25 September 2020

FORT STREET PUBLIC SCHOOL REDEVELOPMENT APPENDIX C – RESPONSE TO REQUEST FOR ADDITIONAL INFORMATION

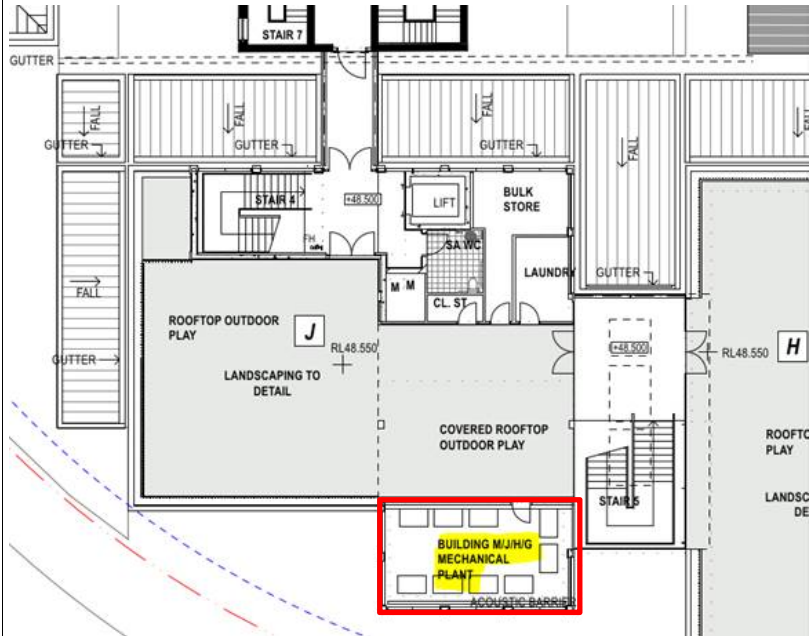
Item No	Request	Response
Request for Additional Information – 6 August 2020		
1	<p>Architectural Design Report (pg 40): can you please confirm whether the plantroom for Building J will be on the eastern or western side. The ADR currently states it is on the western side (see screenshot below)</p> 	<p>The Architectural SD report does note the plantroom as being located on the 'western side of Building J'. It is confirmed that this is more accurately described as the <u>southern side of Building J</u>. This is illustrated in the Figure 1 below which is an extract from plan <i>AR_DRG_010012[15]</i> which shows the location of the mechanical plant room at the southern side of building J.</p>  <p>Figure 1 – Plan extract showing the location of the mechanical plant room at the southern side of Building J</p>
